Attachment 1- Capital Facilities Impact Analysis (Eastern)
ZMAP 2005-0019, Belmont Estates

SUBJECT: ZMAP 2005-0019—Belmont Estates
Fourth Referral

CASE NUMBER AND NAME: ZMAP 2005-0019, Belmont Estates, 6th submission in response to comments and 2nd submission of Proffer Statement review

**RE: ZMAP 2005-0019, Belmont Estates
Response to County Review Comments**

Figure 12: Roadway Geometry - 2013 Build-Out Conditions - Alternative 2

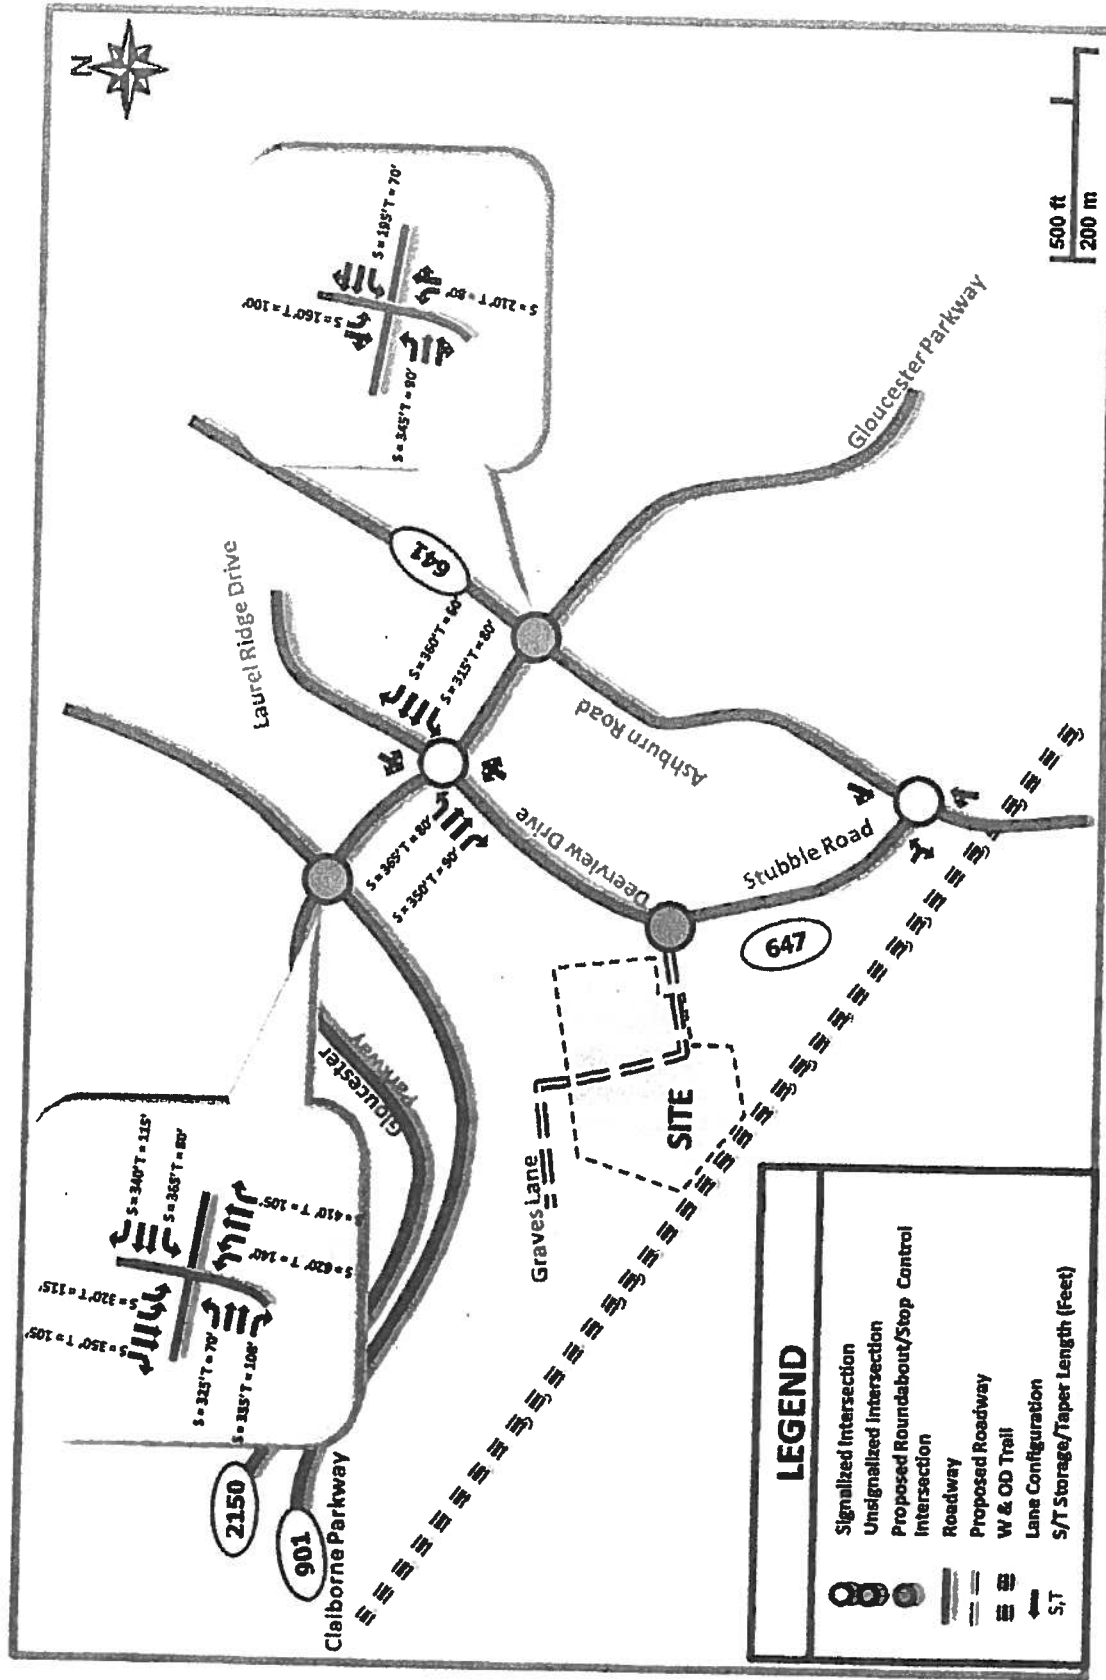
2. The traffic study notes that Alternative 2 (with the Deerview Drive/Stubble Road connection in place) results in better levels of service than Alternative 1 (without the street connection). OTS recommends that Alternative 2 be pursued, as this would result not only in better LOS (as indicated by the study) but also would result in increased street connectivity, which is consistent with policies contained in the Revised General Plan and the Countywide Transportation Plan.

3. Given the traffic study's assumption that Stubble Road would be paved in Alternative 2, the Applicant's proposal (per draft Proffer VII.F.) to leave Stubble Road in an unpaved condition calls the validity of the study's results into question. The Applicant should construct a paved, two-lane section of Stubble Road (as assumed by the traffic study) to a standard that is acceptable to VDOT. OTS would support such an improvement as part of the Applicant's proposed regional transportation improvement contribution in the March 12, 2010 draft proffer statement (Proffer VII.B).

The CDP, as revised March 8, 2010, and Proffer VII.D. provide for the Deerview Drive/Stubble Road connection by utilizing a round-about.
